HPC RESPONSE LETTER

Certificate of Appropriateness
402 W Birch Ave
Flagstaff, AZ 86001
Averbeck ADU

Please see our attached Revision 02 documents for our application for a Certificate of Appropriateness for a new garage/ADU structure at 402 W Birch Ave. The following items have been revised from the Revision 01 documents that were reviewed by the HPC Commission on November 19, 2025.

PROJECT NARRATIVE REV 02

1. SITE PLAN
SCALE: 1" = 20'-0"

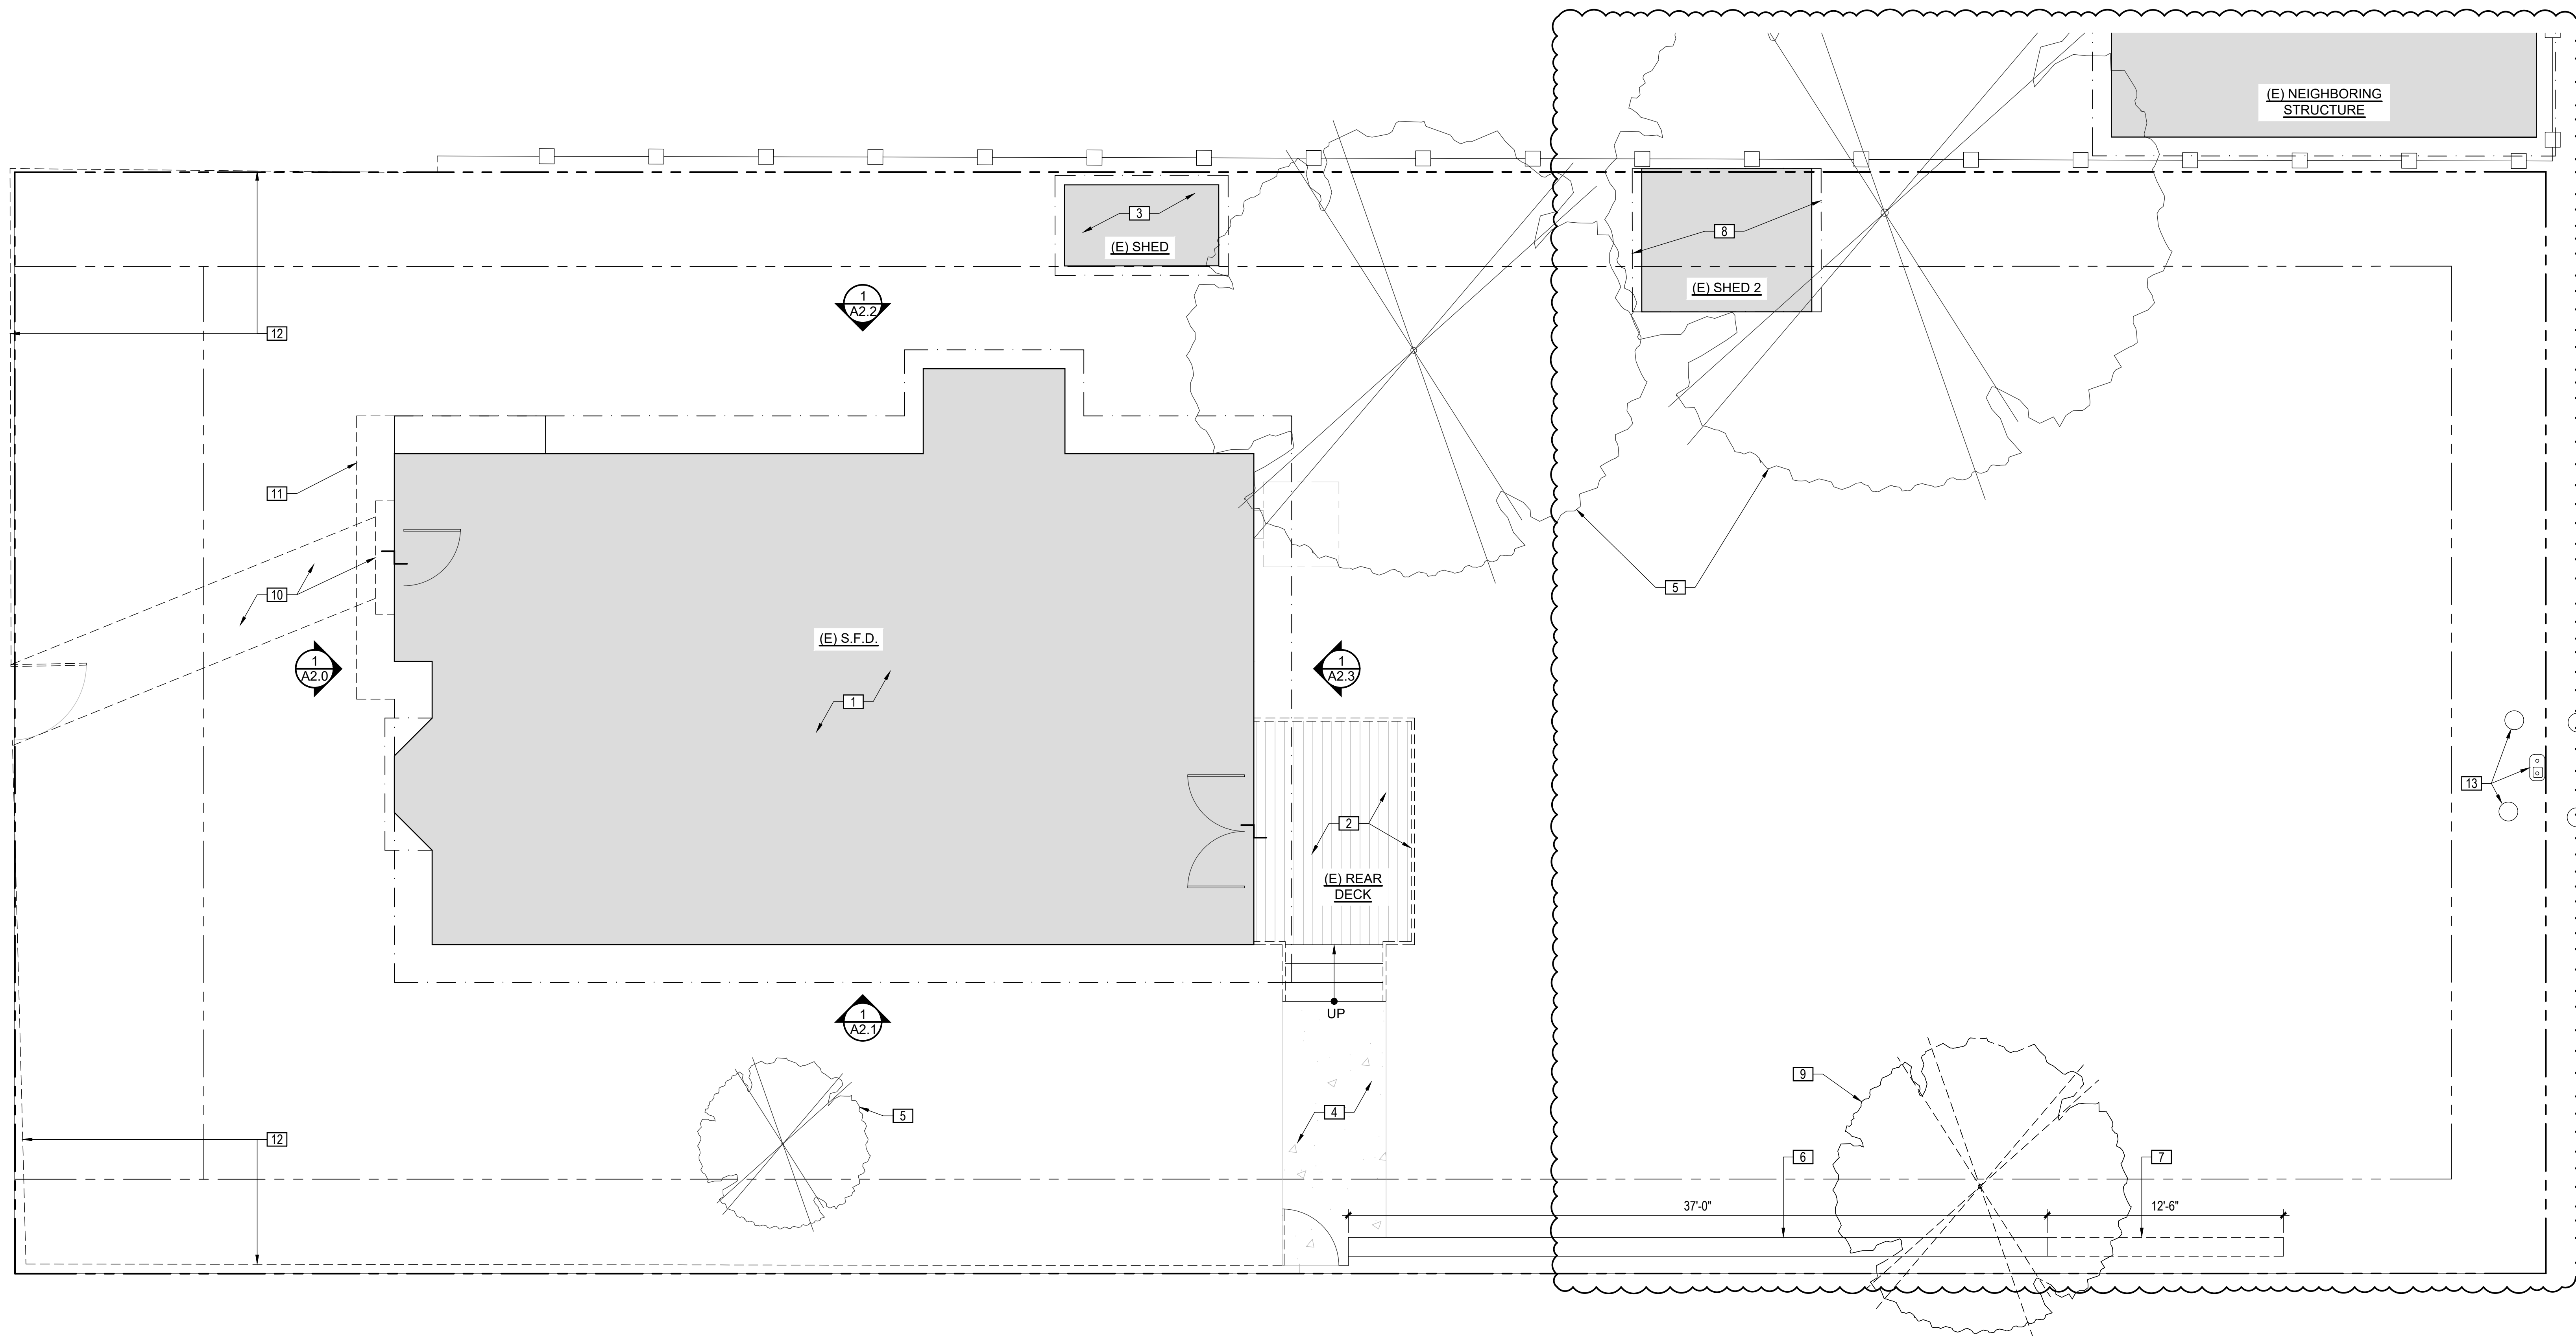
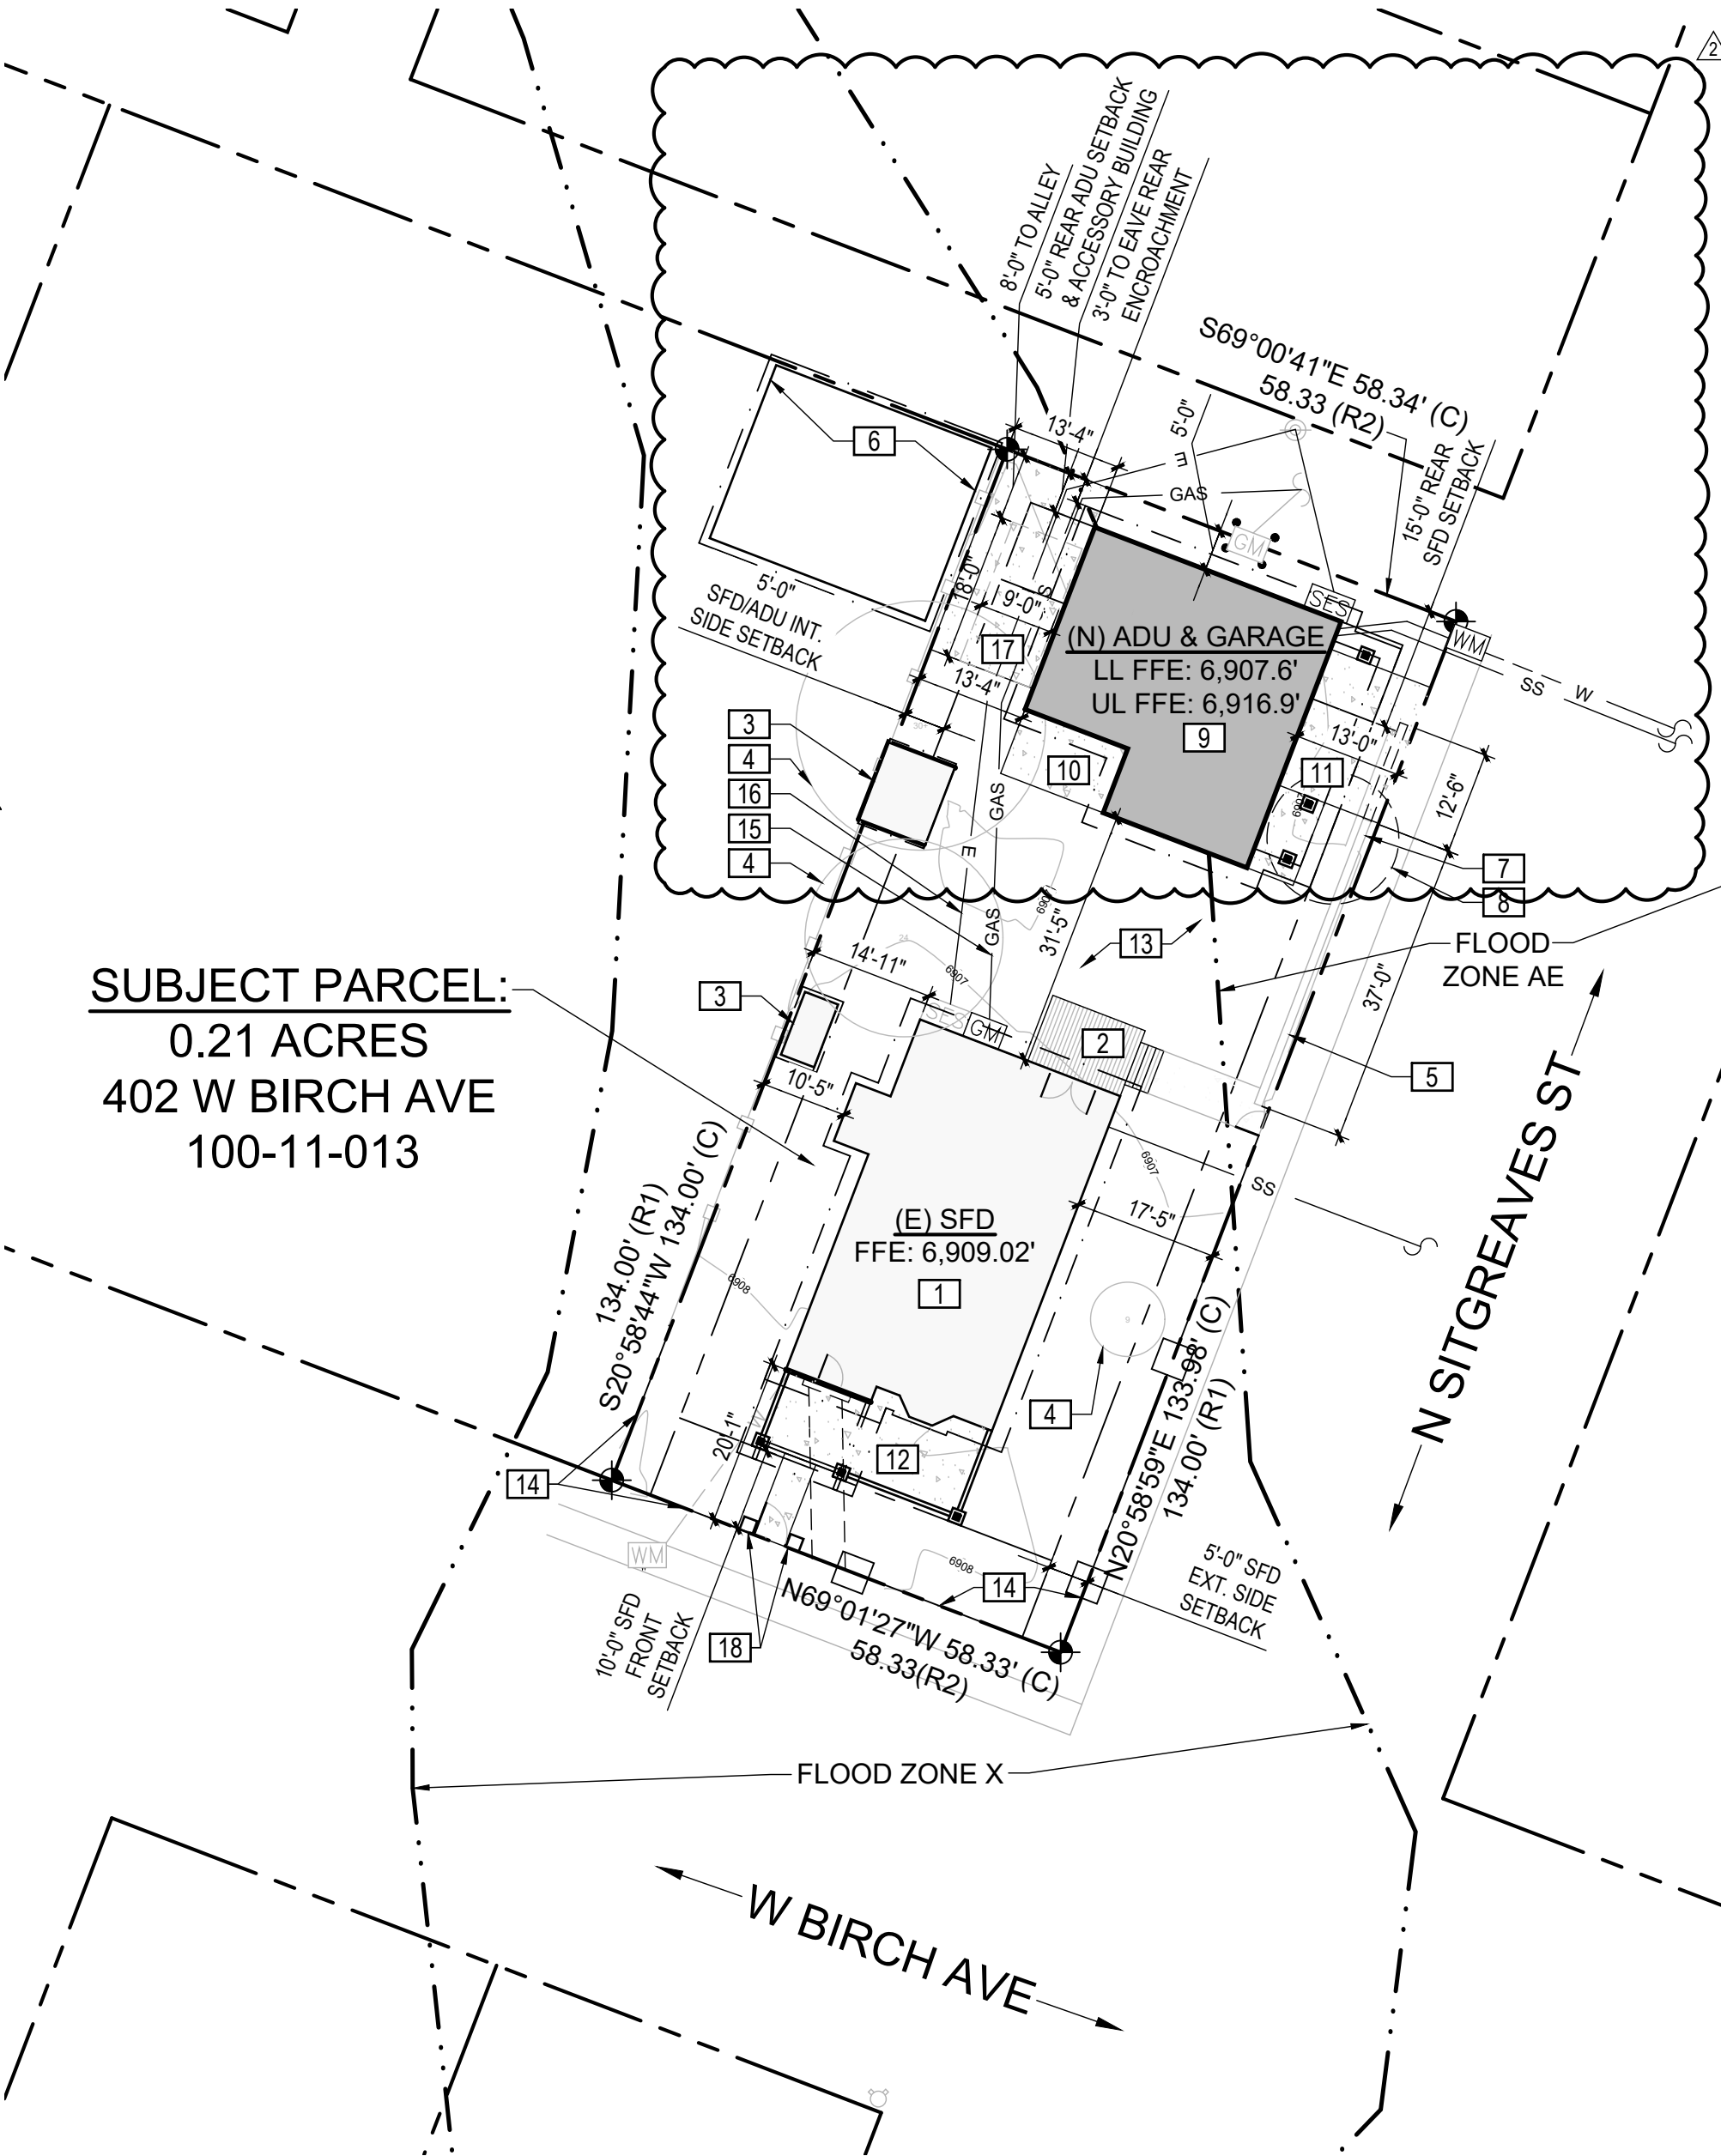
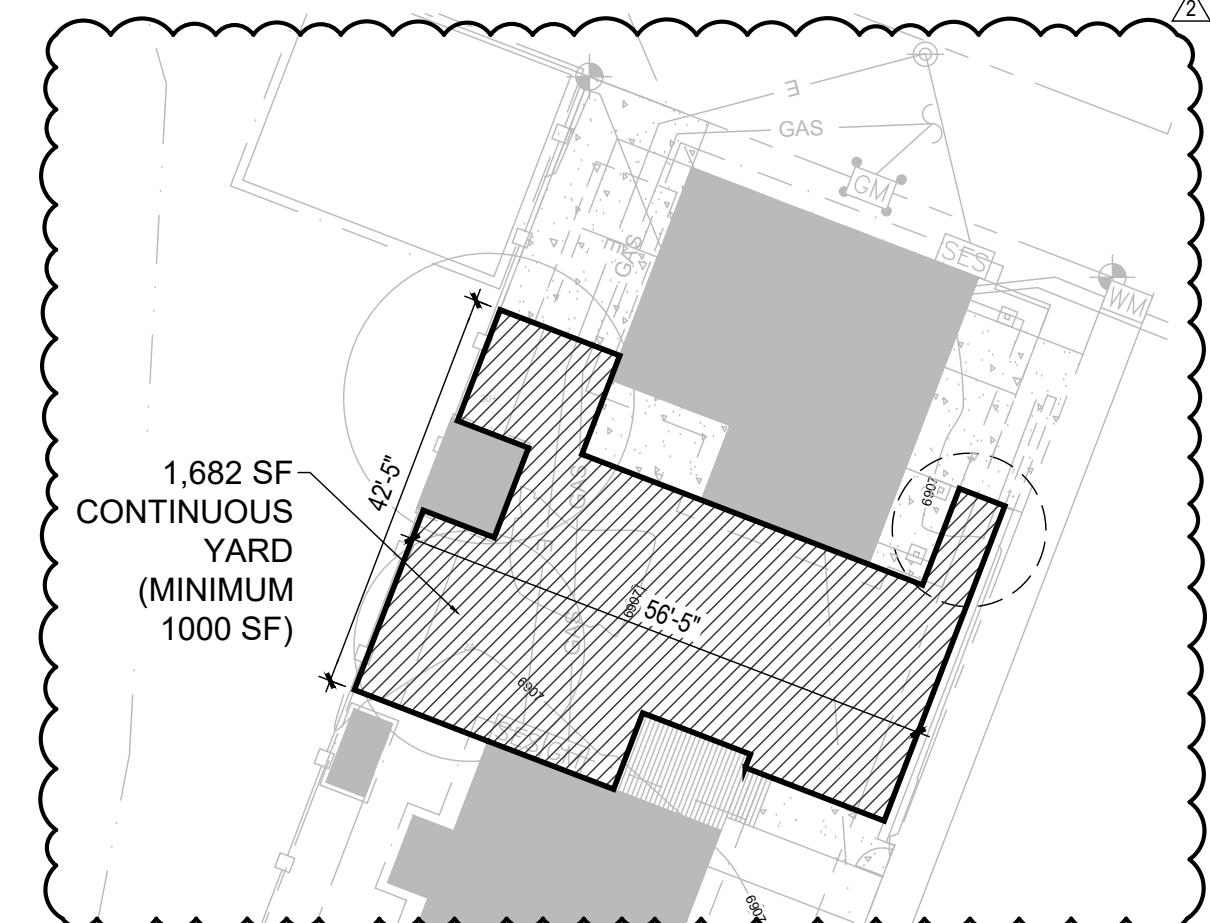
- Relocated proposed structure in order to prevent the demolition of a century-old historical Gravenstein apple tree & create distance from the neighboring structure at the NW property corner.
- Added an additional 9'x18' off-street parking space behind the structure.
- Increased open space from 1,611 sf to 1,682 sf
- Decreased the amount of the existing low site rock wall to be demolished from 15'-6" to 12'-6"
- Both existing sheds along the West property line will be saved.
